**AGENDA**  
**City Planning Commission**  
**June 17, 2026, 5:30 PM**  
**Council Chambers – Hillsdale City Hall**

**Re: Consideration of Applications – 96 W Carleton Rd**

**Re:** Department Head Review – Commercial Site Plan

**Project:** PZ2026-017  
96 W CARLETON RD  
HILLSDALE, MI 49242  
NEW MULTI-TENANT COMMERCIAL BUILDING

Sheet No. C-1.0

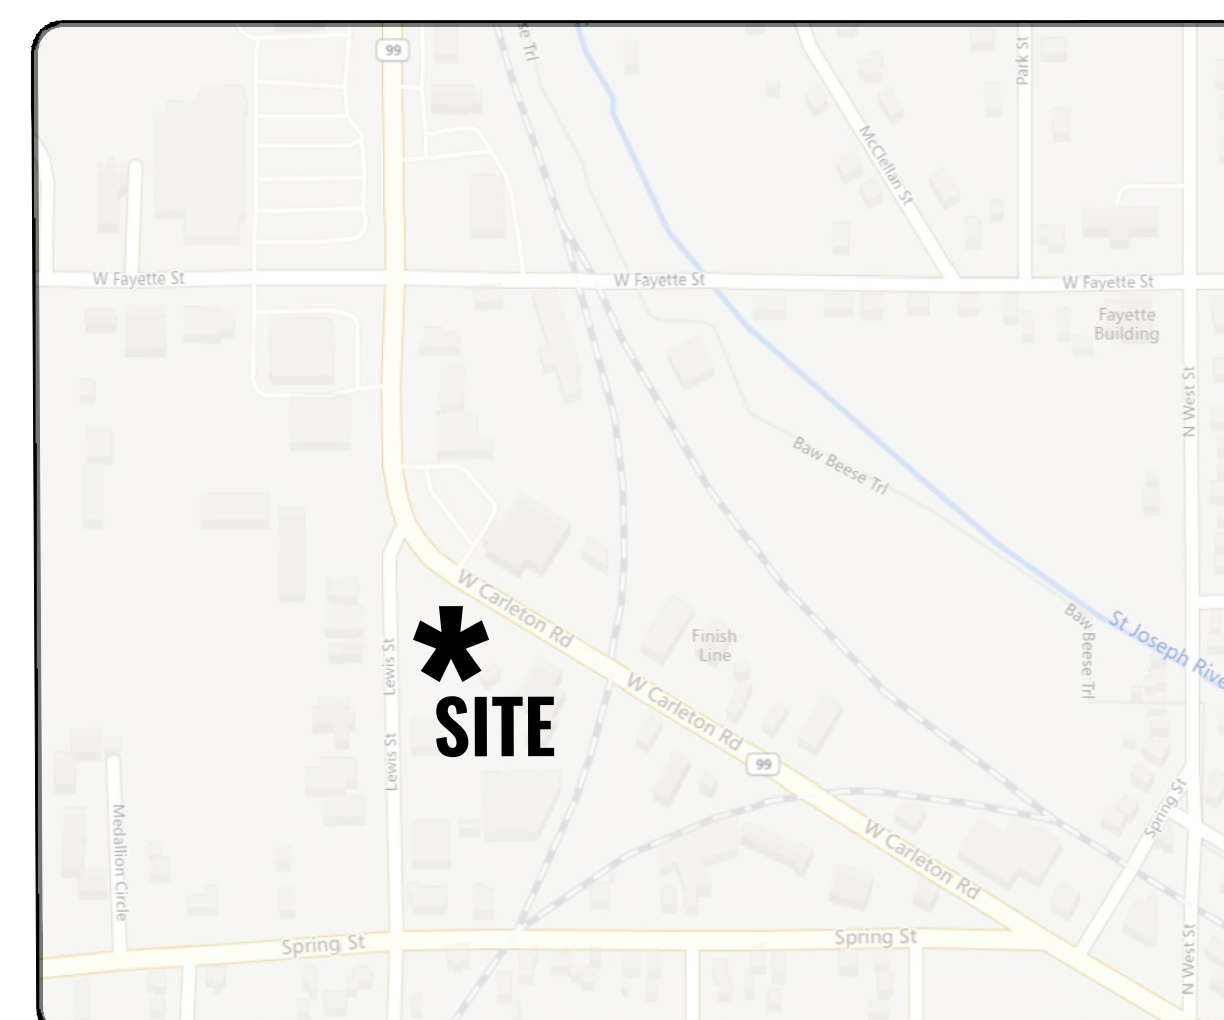
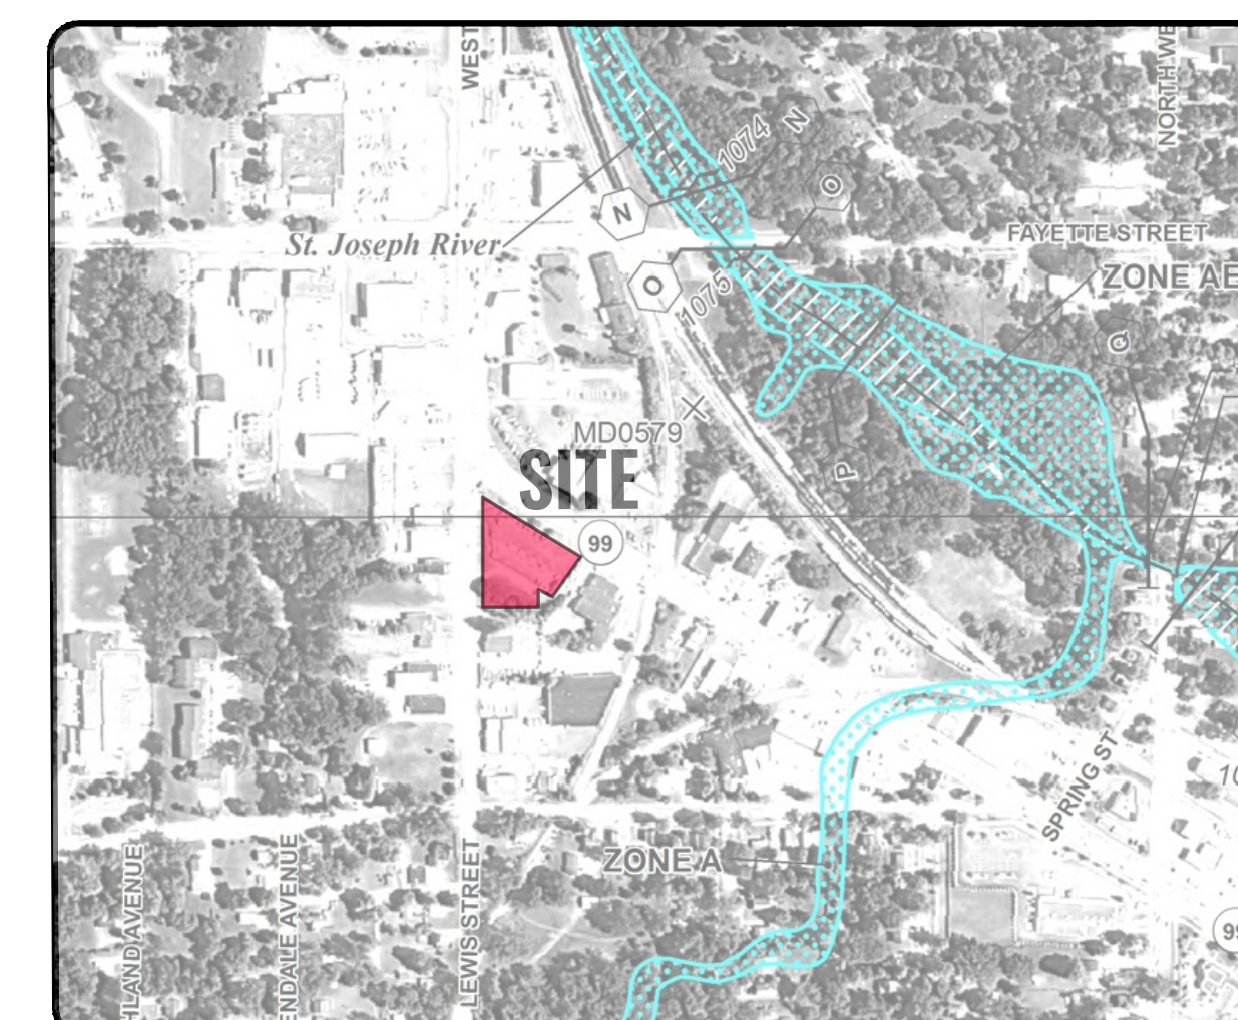
- Municipal contact information correction (C-1.0)
  - Engineering – 45 Monroe St, Hillsdale, MI 49242
  - Public Services – 149 Waterworks Ave, Hillsdale, MI 49242
  - Chief of Police and Fire – 97 N Broad St, Hillsdale, MI 49242
- **Parking stalls need to meet the minimum requirements found in [Sec. 36-623](#).**
  - Parallel parking stalls are a foot short (23' minimum required)
  - The 90 degree stalls are 2 feet short (20' minimum required)
  - Width of 45 degree parking stalls not provided for verification. Length of stalls are 2 feet short (20' minimum required)
- **No required landscaping plan presented with application. An amended site plan including landscaping must be submitted. Per [Sec. 36-149](#), “No site plan shall be approved unless the site plan shows landscaping, greenbelt, and screening consistent with the requirements set forth in this section.”**

Sheet No. **C-3.0**

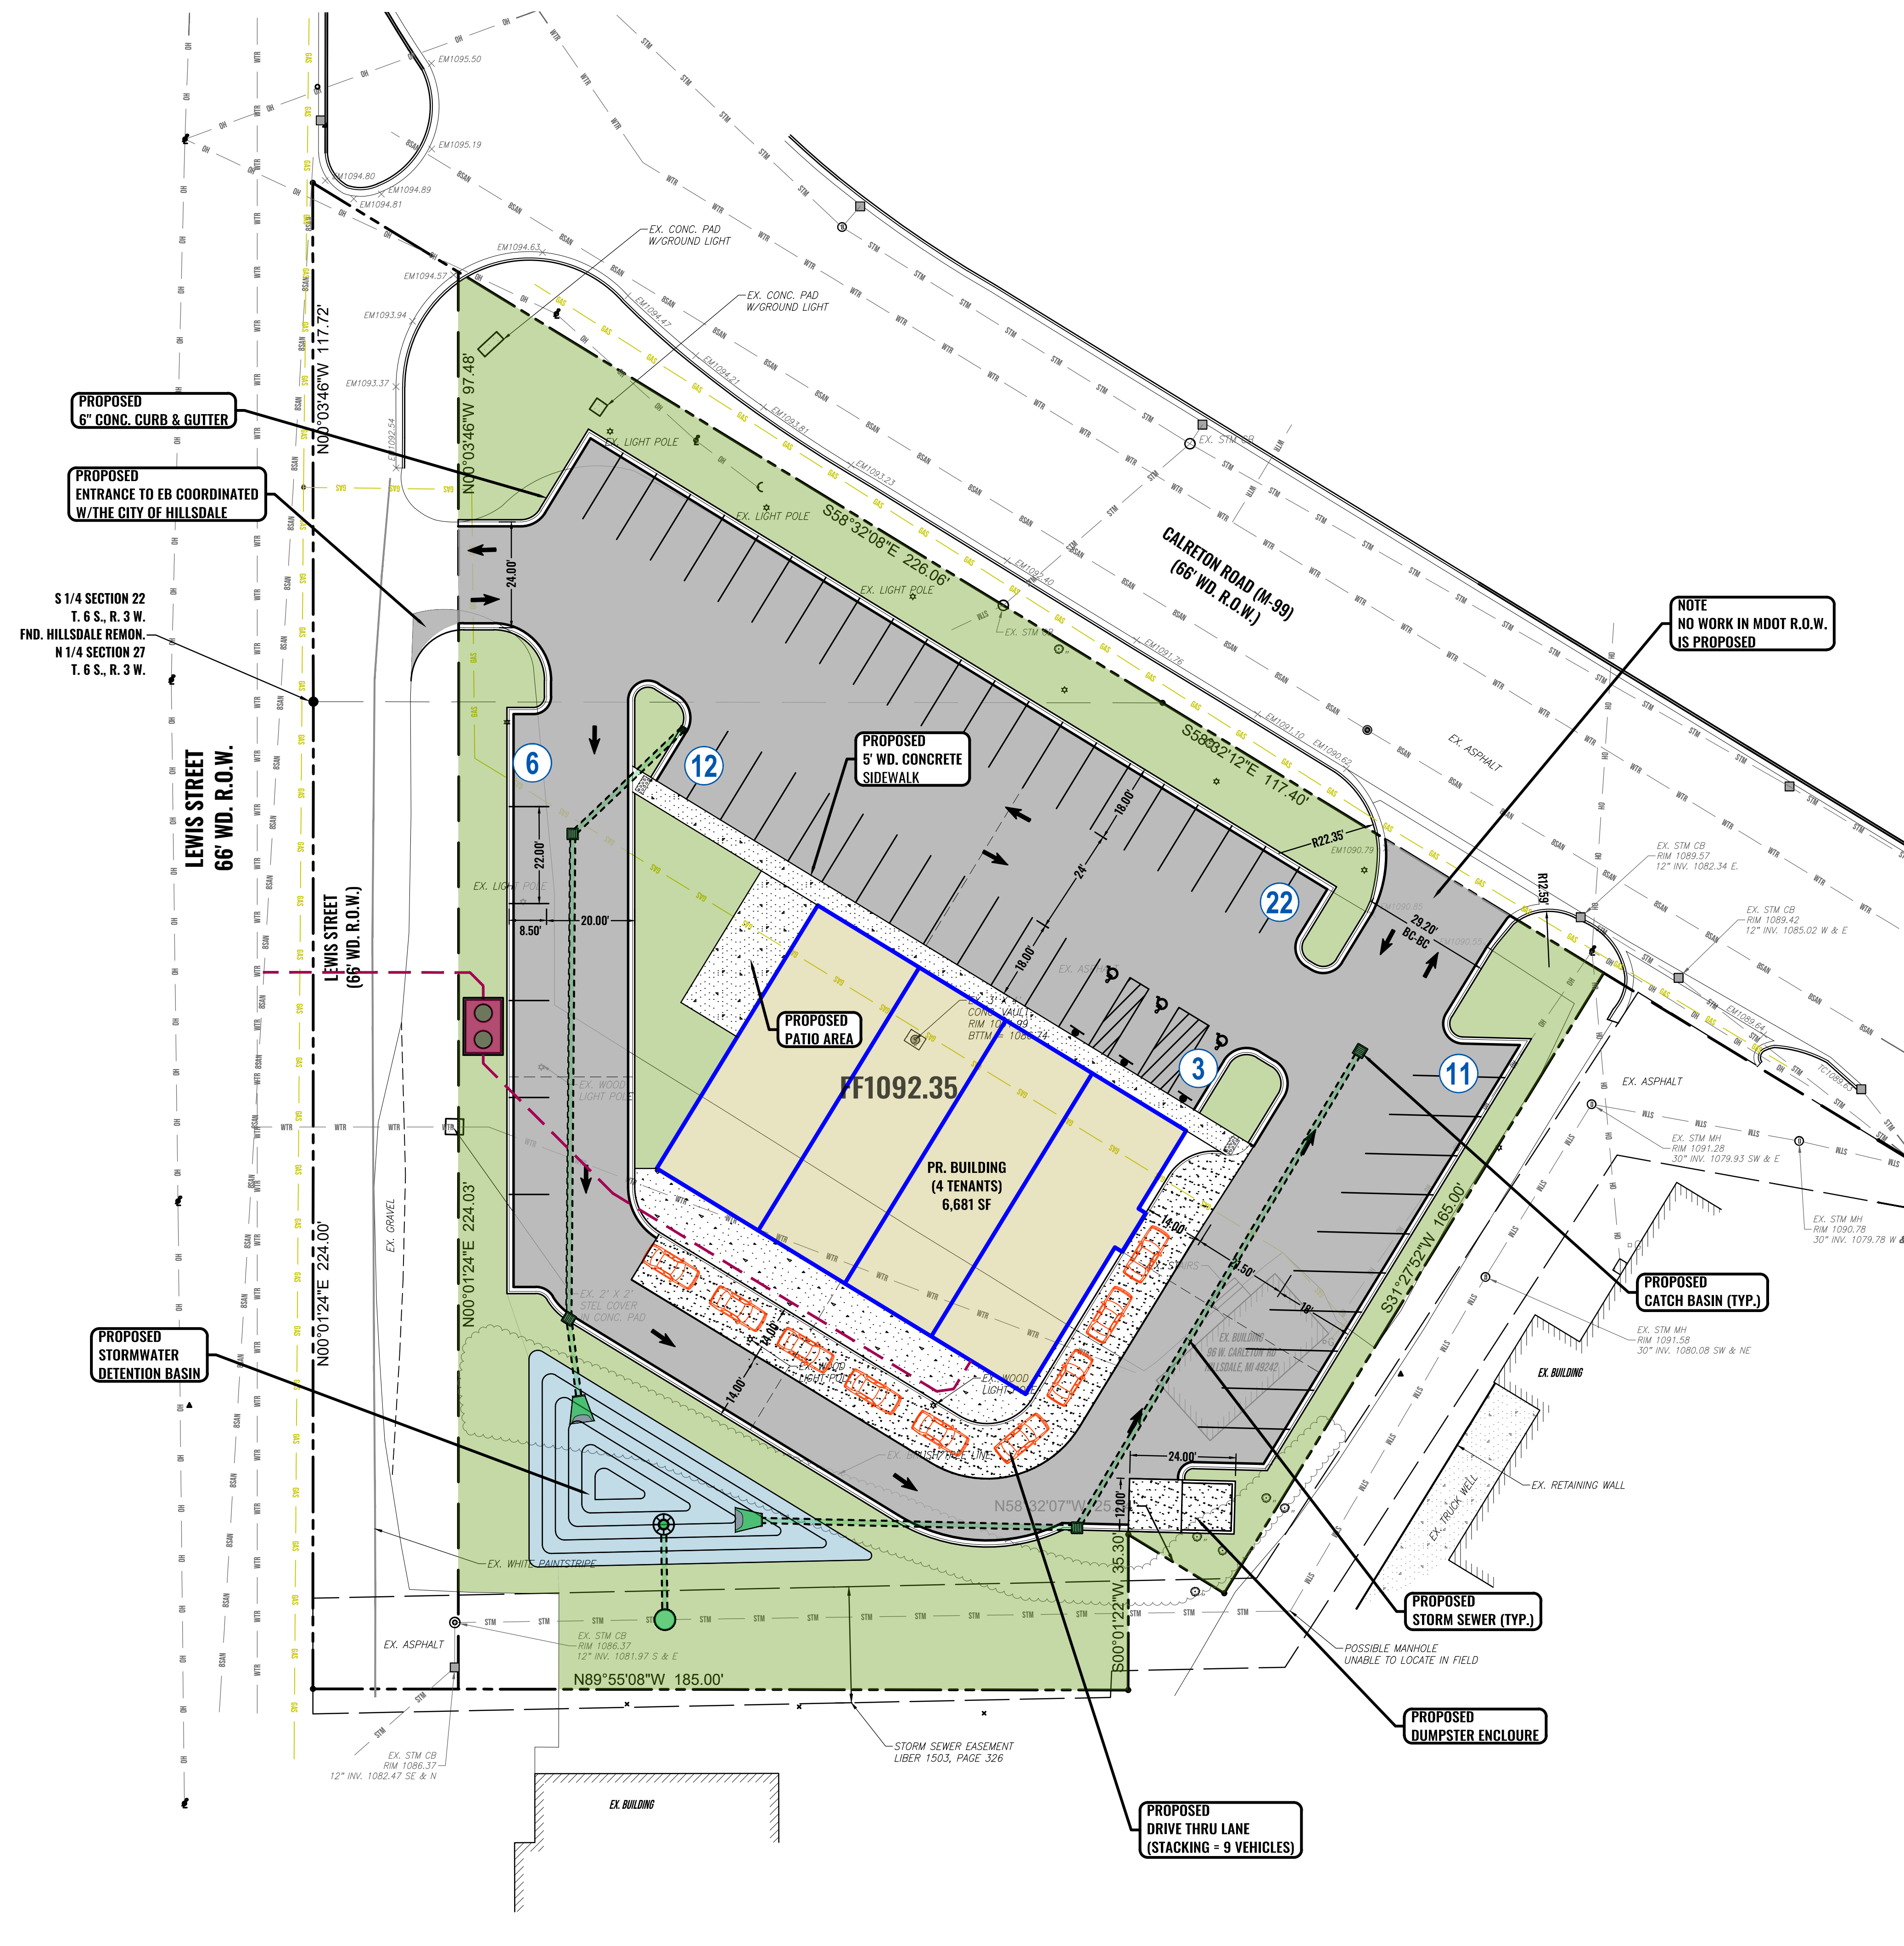
- **Both M99 and Lewis St drive approaches need to be upgraded to MDOT M-opening style**
  - Per Doug Jordan of MDOT-Jackson TSC in a 3/24/2026 email, the access to M99 will need to be built to meet MDOT specifications (34' back of curb wide with 25' radius).
- Traffic impact study, per MDOT request, for the M99 drive approach.
- In the memo submitted with the application, it states, “At this time, no improvements within the MDOT right-of-way are proposed.” And that “MDOT coordination notes associated with M-99 frontage improvements and access considerations” were “incorporated into the submission package.”
  - **Applicant must provide plan approval and comments from MDOT staff.**

- Recommend that the ADA ramps for the handicap parking be shown. The van accessible access aisle alignment looks to be in line with the door to end tenant space. The sidewalk does not appear to be wide enough to allow for the ramp and landing space in front of the door. A 10' sidewalk would allow for a ramp to be in-line with a door and have a 5' landing area in front of the door. Or, the ramp needs to be offset from the door (similar to how the 5 access aisle is located).
- With an 18' parking stall, larger trucks will likely overhang the sidewalk. The sidewalk should be 7' wide, if vehicle overhand is considered.
- Recommend that the Lewis St drive entrance be a minimum of 60' from the radius point of the intersection with Carleton Rd.
